STAFF REPORT: 02/07/2024 REGULAR MEETING

APPLICATION NUMBER: HDC2024-00021

ADDRESSES: 1475 RANDOLPH (BEATRICE BUCK’S PARADISE VALLEY PARK) AND GRATIOT PLAZA (ADJACENT TO 1407 RANDOLPH)

SCOPE: ALTER PARK AND PLAZA

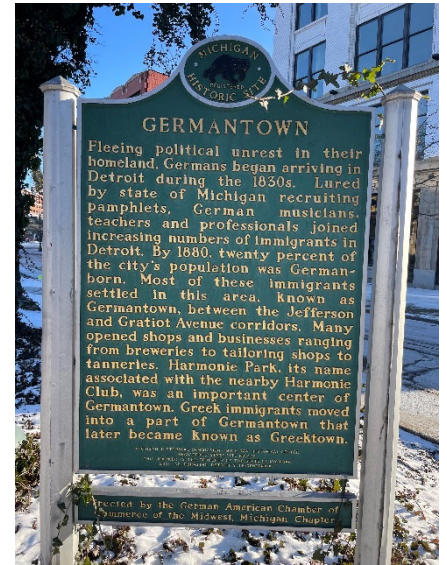
- It is staff’s opinion that the work proposed within the portion of the Gratiot Plaza which extends into the district meets the Secretary of the Interior’s Standards and complies with the district’s Elements of Design.

- Strictly within the limits of the historic district, staff has no issue with the addition of a stair and other planting recommendations in the plaza.
